**Coal Combustion Waste Impoundment  
Round 5 - Dam Assessment Report**

*Lansing Smith Plant (Site #07)*

*Ash Pond Embankments  
Gulf Power Company  
Southport, Florida*

Dewberry & Davis, LLC  
Fairfax, Virginia

**Figure 4.1.2 a: Ash Pond Impoundment Remedial Work Cross-section**

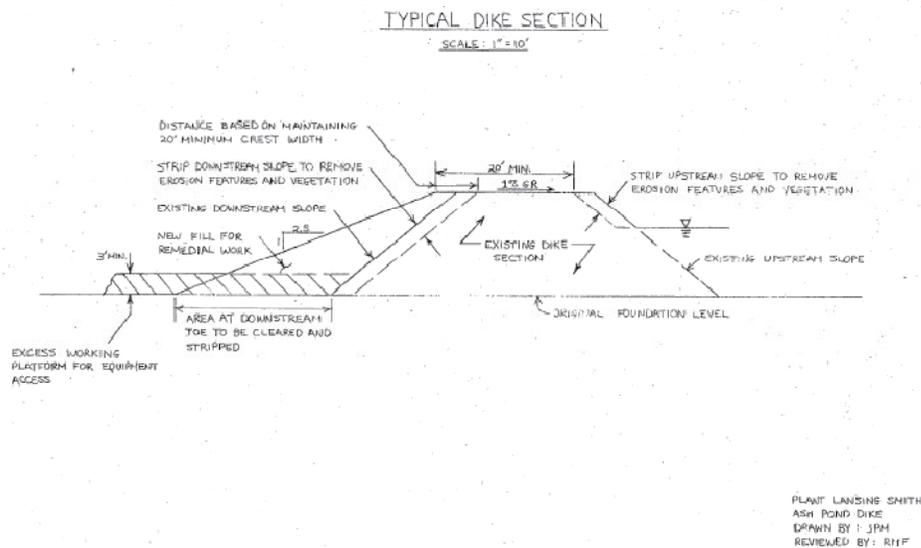
The original material of the dam embankment was not provided. Test results were provided for a modification and a recommendation was made. We do not have any test results, reports or construction drawings of the modification verifying the materials and their properties.

There are multiple references describing some remedial work that needed to be done to the Ash Pond Dike. The figure below shows a cross section of the plans to remediate the dike (see Appendix A: Doc 05 – Remedial Work Dike Section). No documentation was provided on the construction or tests results of this work.

2010 - Inspection Photographs - Feb. 10, 2010  
(See the accompanying report attached)

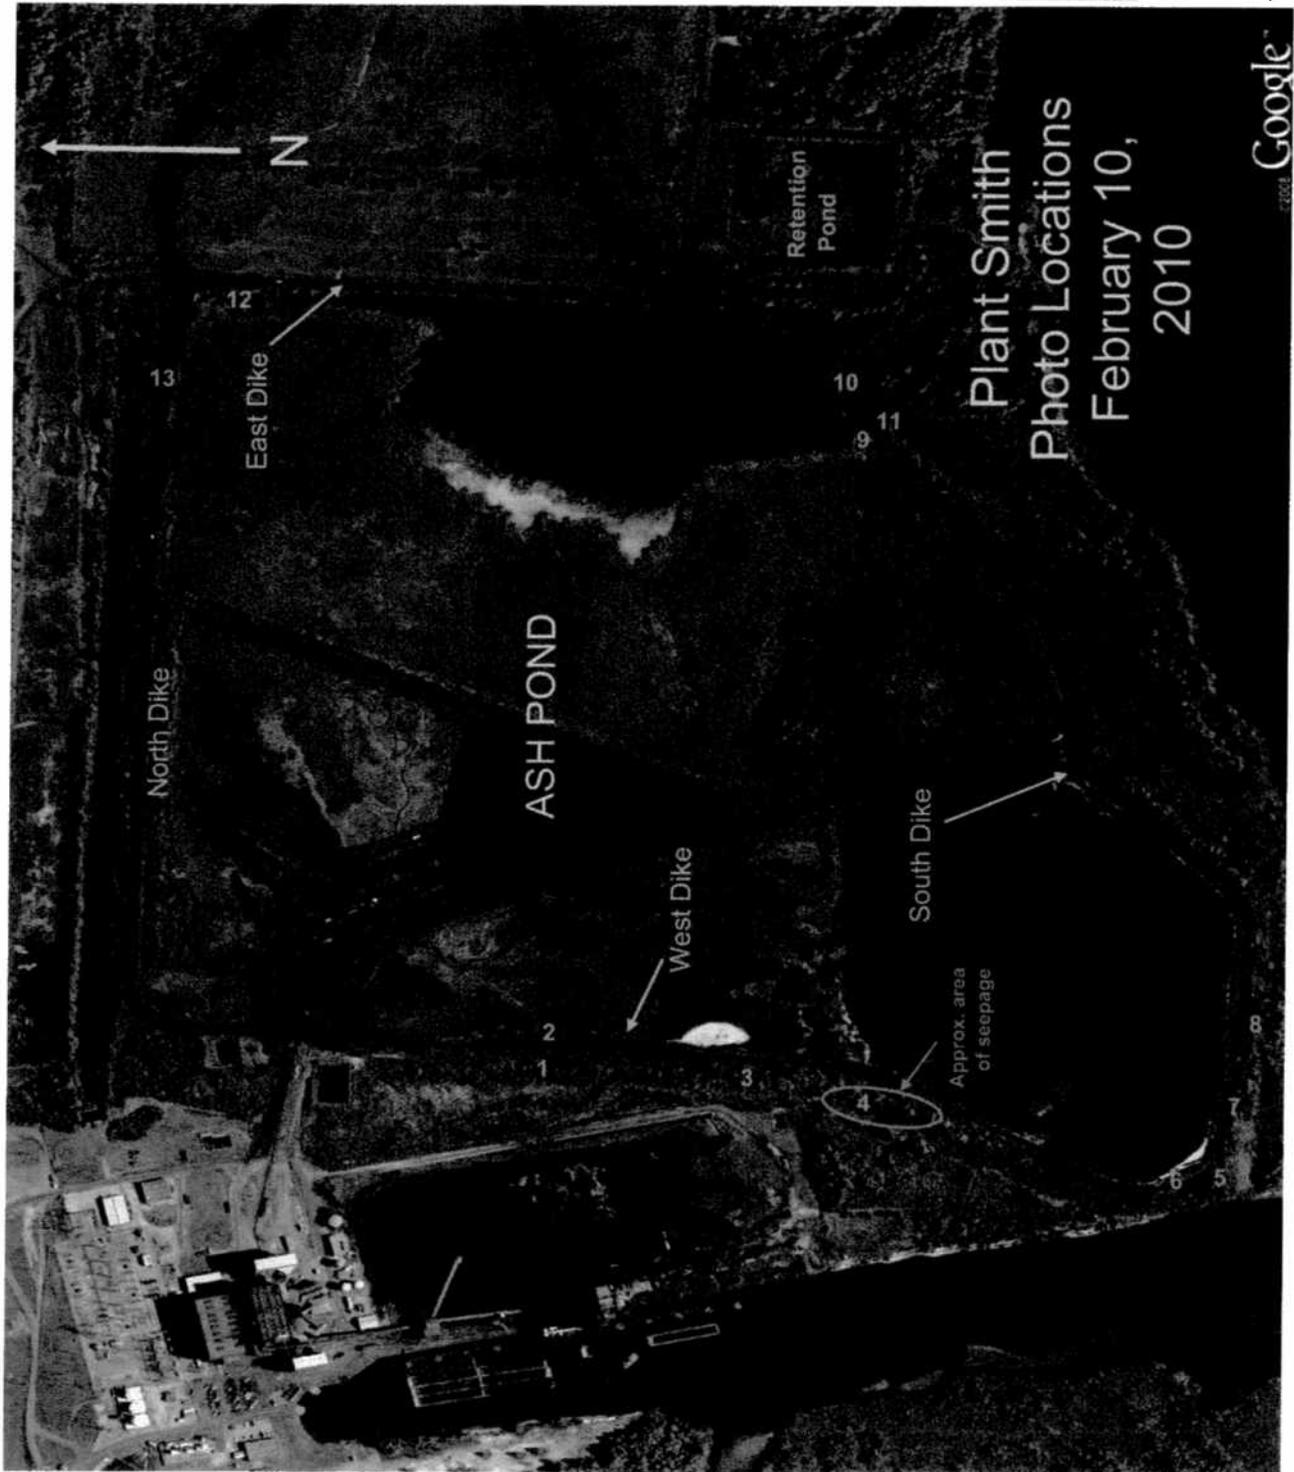
a. Condition	Generally good; brush and trees have been removed and root ball areas repaired; some rye grass beginning to grow; <b>Recommendation #1</b> - Plant (hydroseed) additional grass for summer growth. Some trees and brush at toe of slope must be left to avoid encroaching on wetlands.	3

b. Seepage/Wet Spots	Yes (X) No ( ) Several areas of seepage up from toe about 2' to 3', very small flow along ~50' length of dike; <b>Recommendation #2</b> - Monitor this area as part of weekly plant inspection. Any sloughing or loss of material observed during the weekly inspection (or at anytime) should be reported to SCG Hydro Services immediately. See the attached aerial photo for location.	3 and 4
